01-12 LATEST REVISION DATE <i>Norman E. Mc Donald</i> APPROVED BY BRIDGE ENGINEER		
	STANDARD DESIGN - 40' ROADWAY, 3 SPAN BRIDGES ROLLED STEEL BEAM BRIDGES JUNE, 2010	
	LONGITUDINAL SECTION 45° SKEW	RS40-028-10

PART END VIEW AT ABUTMENT

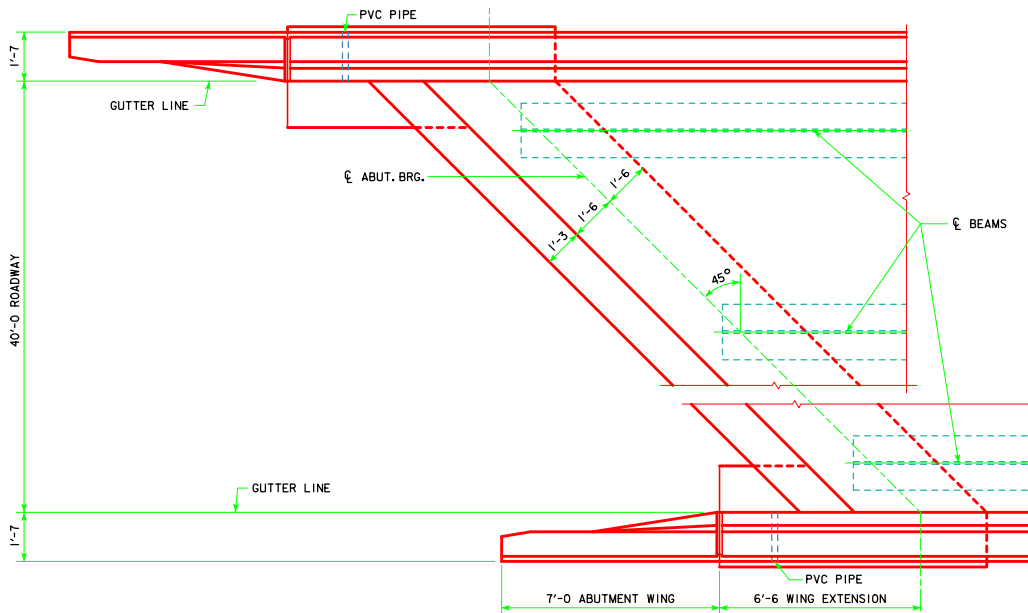
REVISED 01-12 - ADDED FIELD BEND 5h4 BAR TO AVOID PILE IN ABUTMENT WING NOTE.

FIELD BEND 5h4 BAR AS NECESSARY TO AVOID PILE IN ABUTMENT WING.
